## Certificate of Appropriateness

2636 N. GRANT BL.

PTS ID 115015 COA: rear balcony and garage roof

## Basic Railing and Newel Post Design

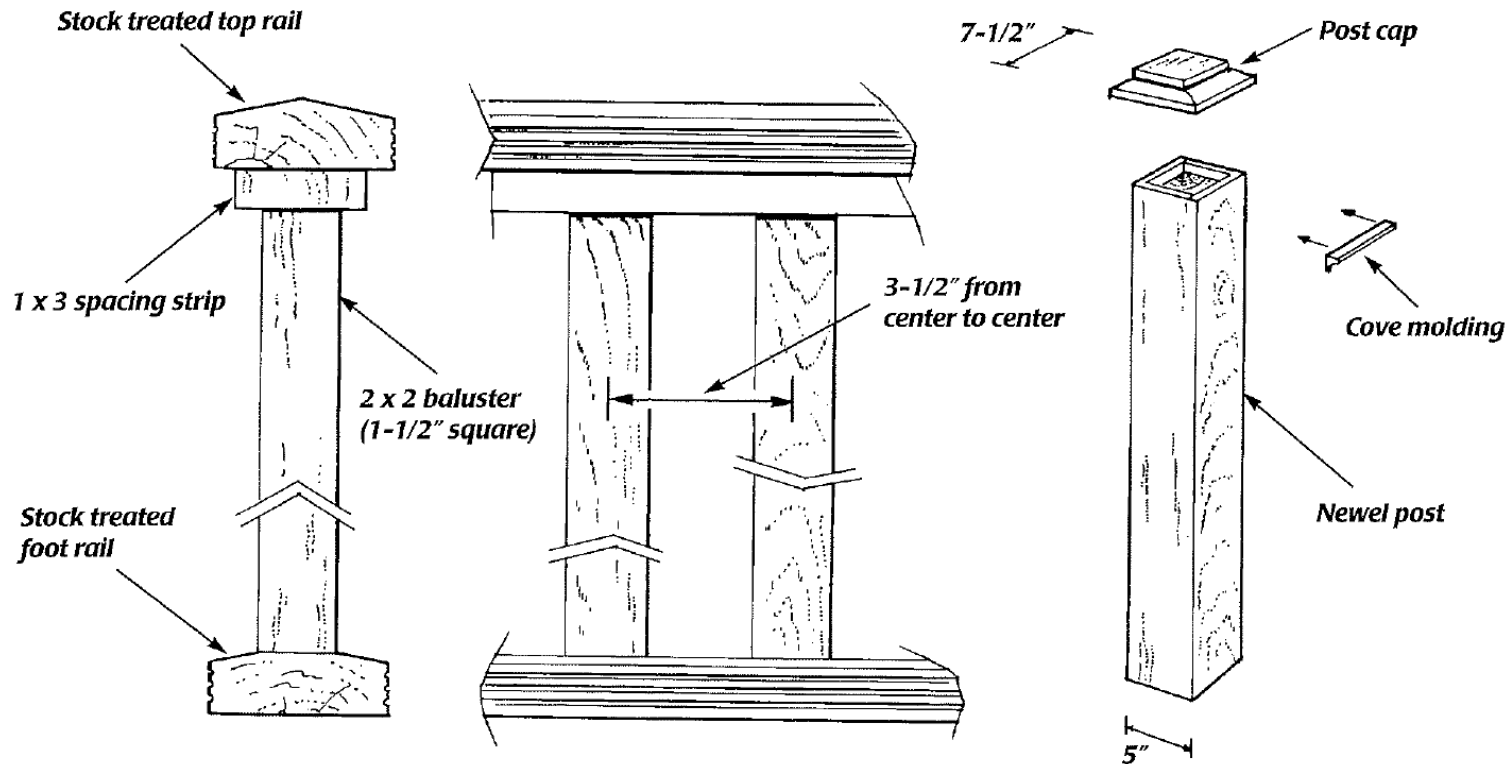
New railing design. Top rail may vary, but must have a top surface designed to shed water. A flat 2x4 or other dimensional lumber is not acceptable.

- Replace railing to match attached standard design. Wood shall comply with conditions listed below and be painted.
